**Re: Docket No. NHTSA–2022–0013; Fed. Reg. Vol. 87, № 35, February 22, 2022**

The SAE Lighting Systems Group would like to thank the National Highway Traffic Safety Administration for publishing a ruling on Adaptive Driving Beam (ADB) systems and appreciates the opportunity to provide comments to Docket No. NHTSA-2022-0013 via our Regulatory Cooperation Task Force (RCTF).

**Figure 1 – Typical real-world example of an overlapping/staggered ADB pattern compared to upper beam requirements**

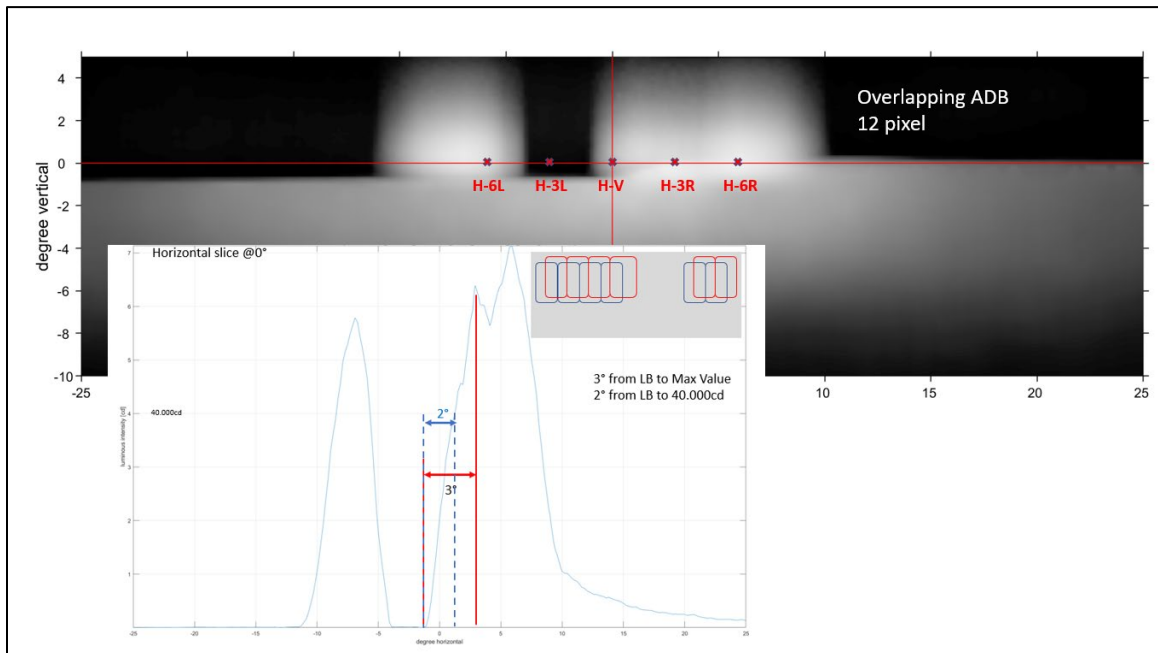
With this technique, the area of unreduced intensity does not reach full upper beam levels within the 1 degree specified, especially at the H-V, H-3L, and H-3R upper beam test points. These affordable ADB systems will provide much greater illumination versus standard lower beam in these enhanced roadway visibility areas but cannot transition between lower beam photometric intensities to upper beam photometric intensities in the currently specified 1 degree transition zone.

An example is shown in Figure 1. This figure illustrates the light output of a 12-segment ADB system projection along with a graph of the intensities for a horizontal slice through the beam pattern at 0 degrees vertical. The area of unreduced intensity would not be able to fulfill the upper beam requirements for approximately 3 degrees. Additional examples are shown in Appendix 1, which represent required transition zones from approximately 1.9 degrees for an 84-pixel system (high resolution) to 7.8 degrees for a 6-pixel system (low resolution).

The most straightforward regulatory resolution to this concern is to not explicitly constrain or define the size of the transition zone. However, the ADB final rule preamble explained NHTSA's reluctance to allow this. An alternative proposal would be to enlarge the allowed transition zone to 4-degrees in the horizontal direction. Based on the data collected within the industry, this would allow the deployment on U.S. roads of affordable ADB systems to provide enhanced roadway visibility immediately around opposing or preceding vehicles without affecting their glare exposure.

Figure 2 – ADB performance for regions outside of the US following UN regulations or SAE J3069™

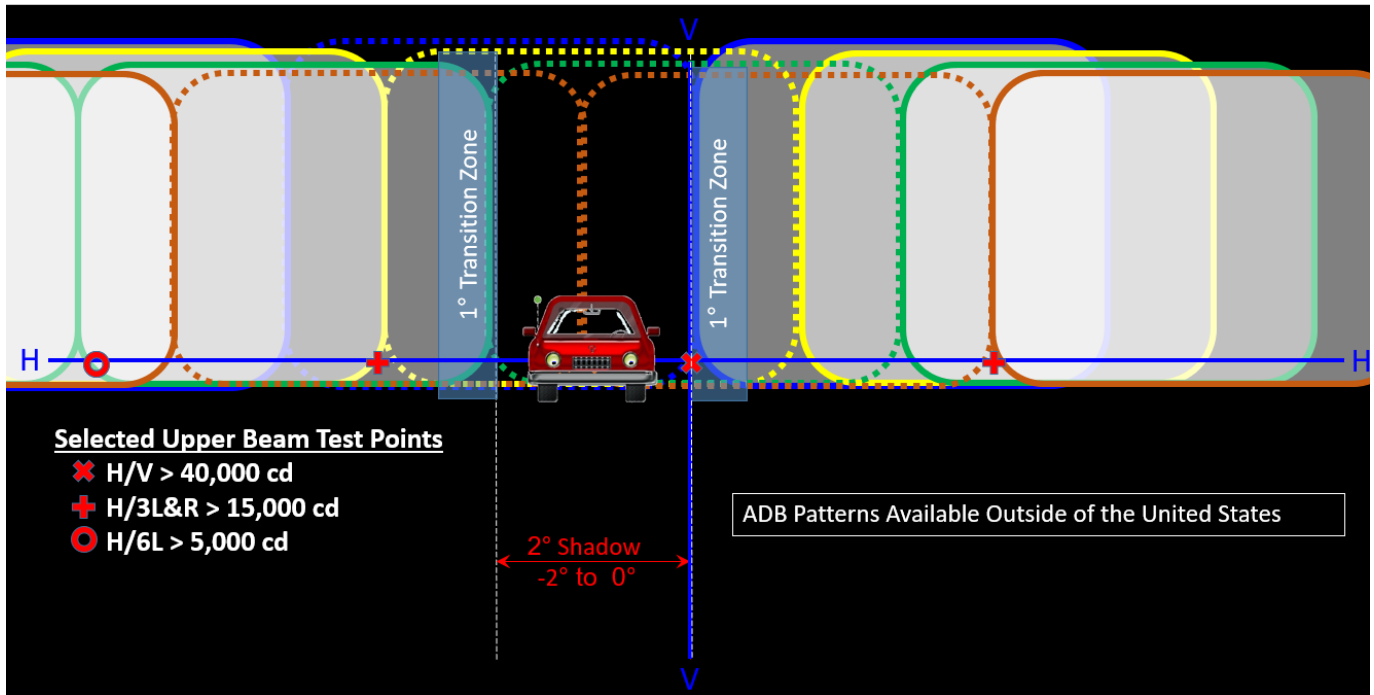
Figure 2 is a representation of a single headlamp with staggered overlapping ADB segments. Superimposed onto this graphic is a representation of a single opposing vehicle at approximately 100m distance. The resulting ADB locally dimmed pattern is shown for a system functioning to the regulatory requirements of regions outside of the United States. This results in a fully dimmed pattern for the opposing vehicle, but the ADB-equipped driver has the benefit of the additional light (visibility) greater than lower beam levels to each side of that opposing vehicle. While this additional light is less than upper beam photometric levels, the intensity is still far above what is provided by the standard lower beam in that enhanced roadway visibility area. However, this partial upper beam intensity is unlikely to meet all upper beam minimum criteria with the 1-degree transition zone defined in the ADB final rule.

Figure 3 – ADB Performance Required to Comply with FMVSS № 108

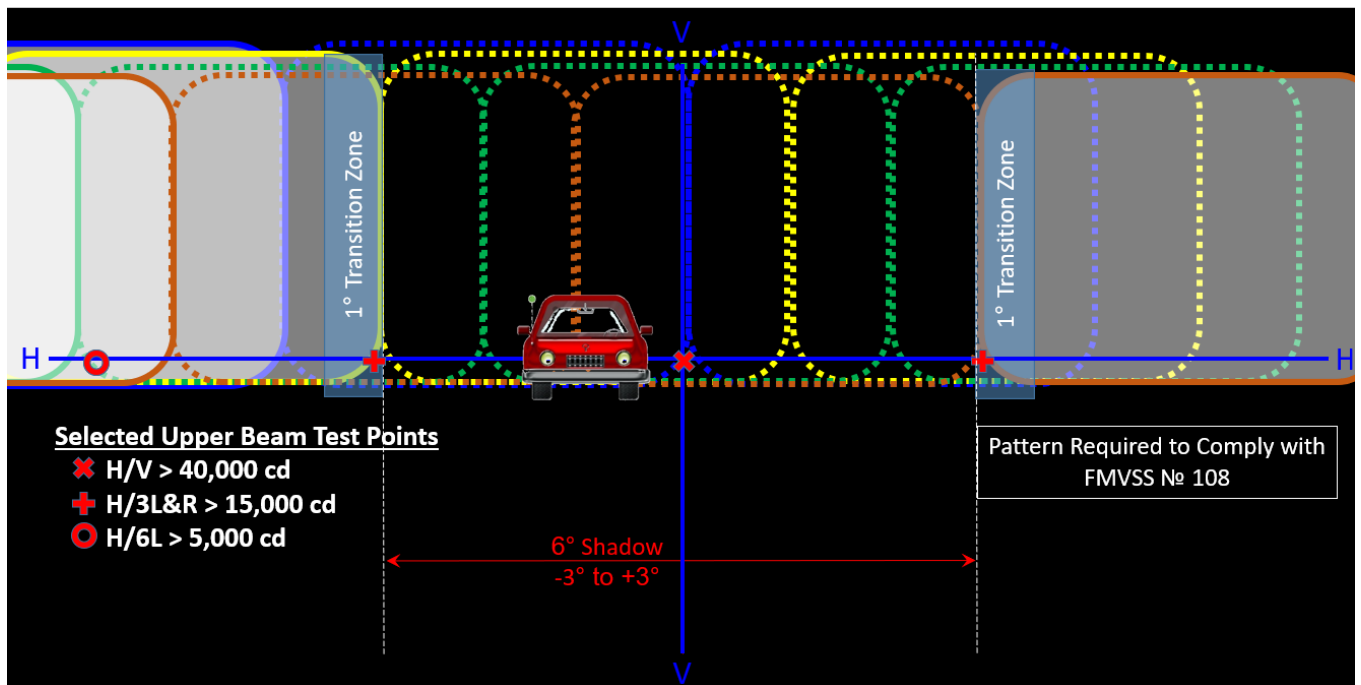
However, as Figure 3 illustrates, to comply with the FMVSS № 108 requirement for full upper beam intensity beyond the 1-degree transition zone, the area of reduced intensity would have to extend laterally well beyond the opposing vehicle. In this representation, the width of the reduced area would enlarge from 2 degrees to 6 degrees to include the regulated (laboratory testing) upper beam test points which would not meet the Figure 2 partially dimmed example. Therefore, instead of partial upper beam intensities, this area would only allow standard lower beam intensity levels. The ADB-equipped vehicle driver would lose the visibility benefit of the additional light in these areas of the roadway and/or curbside regions and would be constrained to lower beam light levels in this enhanced roadway visibility region.

Figure 4 – IIHS glare measurements for a 250m curve radius

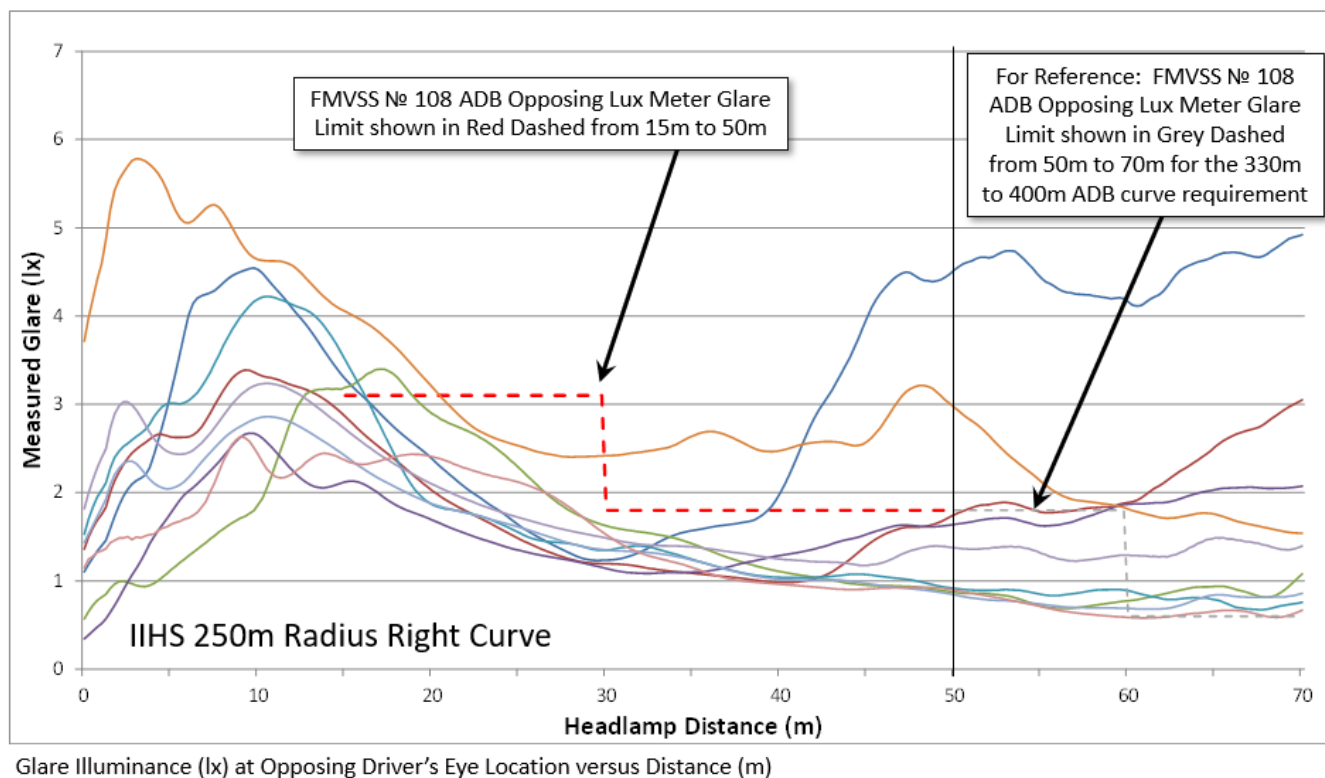
The SAE RCTF also appreciates the steps taken to lessen impact of the glare restrictions in the right-hand curve test scenarios by reducing the distance at which those glare requirements are to be measured. The Insurance Institute for Highway Safety (IIHS) data provided in the SAE comment to the NPRM (NHTSA-2018-0090-0167, December 11, 2018) supporting this need have now been updated to 2021 model year vehicles and are shown in Figure 4. Unfortunately, this data indicates that this issue still exists despite the improvement with the ADB final rule over the previous NPRM condition.

**Figure 5 – 400m right radius curve isocandela view of ADB vehicle glare requirements superimposed onto the lower beam photometric requirements showing conflict at 0.5U 1R-3R**

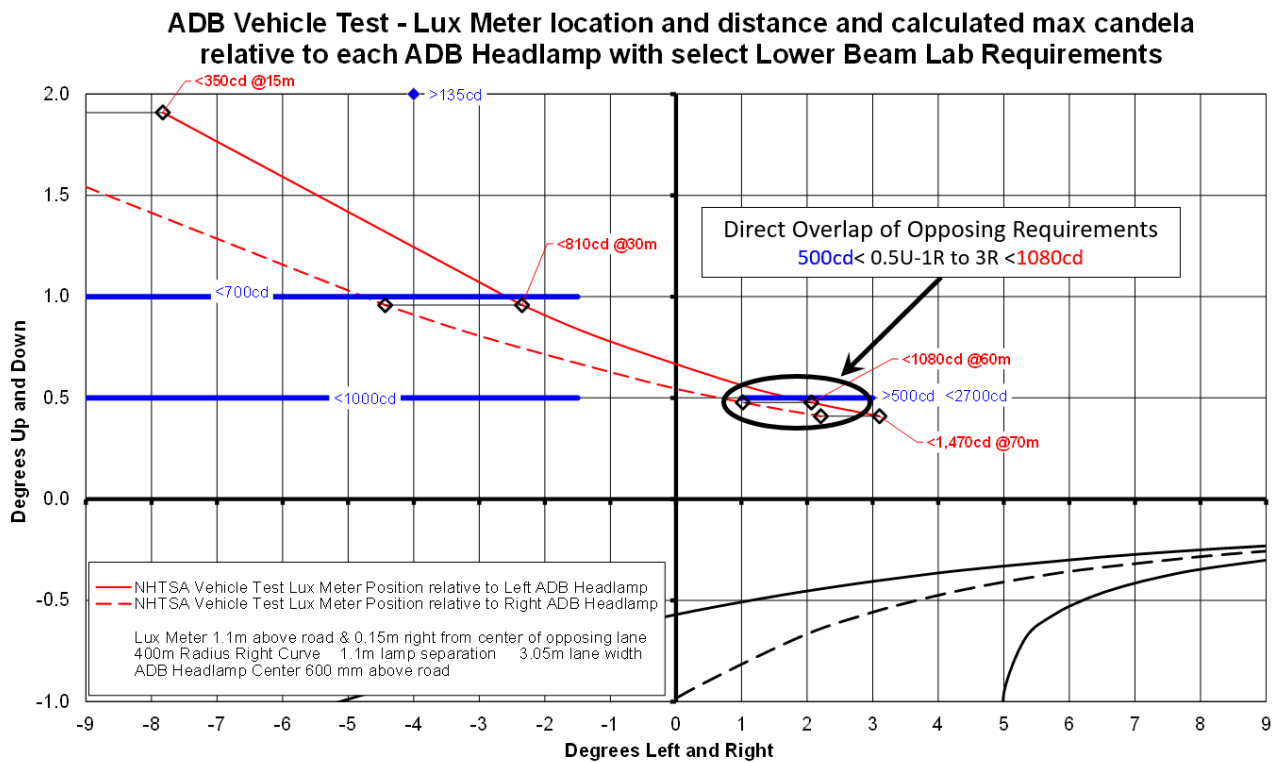
To further clarify, one area in which intersecting requirements exist is at the lower beam photometric test line of 0.5U, 1R to 3R. This particular lower beam photometric scan requires a minimum intensity of 500 cd throughout, while allowing a maximum of 2,700 cd anywhere along the line. During the right curve ADB test scenarios, the glare detectors on the test fixture will have a relative travel path which will cross this same test line at some test distance (this distance varies with factors such as curve radius, headlamp mounting height, etc.). Therefore, the dynamic vehicle test is also imposing a glare limit on the same region of the beam pattern which does not match the corresponding laboratory requirement.

An example of this is illustrated in Figure 5, showing a 400m right curve and an ADB headlamp mounting height of 600mm. In this example, the current lower beam maximum of 2,700 cd along that line for a single headlamp would now be limited to 2,160 cd from the pair of ADB headlamps. Dividing this value for each of the two headlamps results in approximately 1,080 cd from a single ADB headlamp imposed by the vehicle driving test requirements. However, the laboratory testing minimum of 500 cd is still required for lower beams along that entire photometric scan line. With that conflict, a compliant lower beam providing an intensity not much greater than the minimum intensity required along the 0.5U-1R to 3R line would fail the ADB vehicle testing requirements.

Several potential regulatory remedies were also considered to resolve this issue, taking into consideration the dynamic nature of testing, diverse vehicle designs, and the multiple test scenarios which are included in FMVSS No 108. In lieu of modifying the regulatory requirements for lower beam or increasing the permissible illumination detected during the vehicle tests, the suggested regulatory remedy is to relate the vehicle tests' glare requirements using the lower beam

comparative method as specified in SAE J3069™ section 6.5.1.2. With this method, the glare measured at the test fixture from an ADB vehicle headlamp cannot exceed the intensity levels of that same ADB vehicle's lower beam by more than 25%. This will ensure the ADB system provides similar performance to the standard lower beam without necessitating large downward re-aim and performance degradation of the lower beam.

**Figure 6 – 210m right radius curve isocandela view of ADB vehicle glare requirements superimposed onto the lower beam photometric requirements showing conflict at 0.5U 1R-3R**

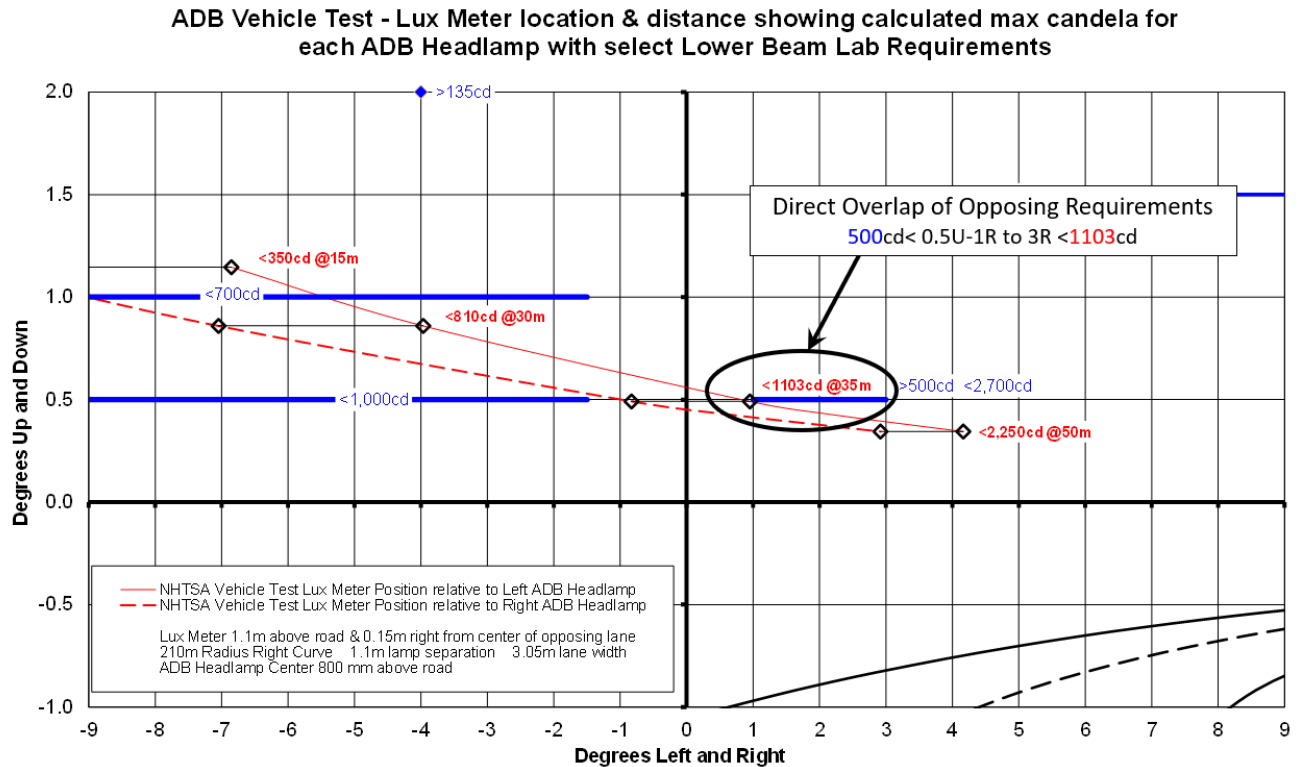
A similar conflict exists for the 210m right curve and an ADB lamp mounting height of 800mm where the upper limit would be approximately 1103 cd per ADB headlamp. This is illustrated in Figure 6.

**Figure 7 – 210m right radius curve isocandela view of ADB vehicle glare requirements superimposed onto the lower beam photometric requirements showing conflict at 2U-4L**

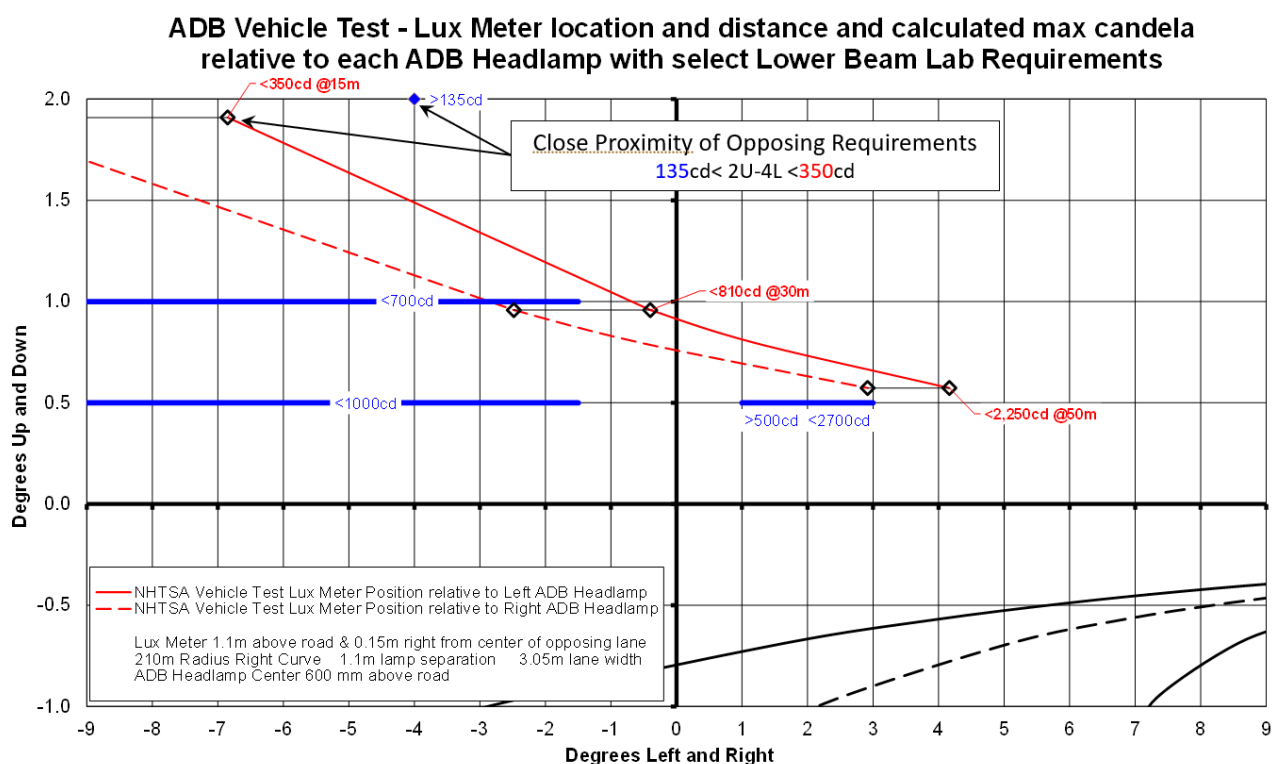
Another area of close proximity of opposing requirements is at the lower beam test point of 2U-4L. This test point requires at least 135 cd. For the 210m right curve at an ADB mounting height of 600mm, the lux meter position for the vehicle test requirements would be in very close proximity to this point at 15m distance, requiring no greater than 700 cd from a pair of ADB headlamps, or 350 cd per ADB headlamp. This is illustrated in Figure 7.
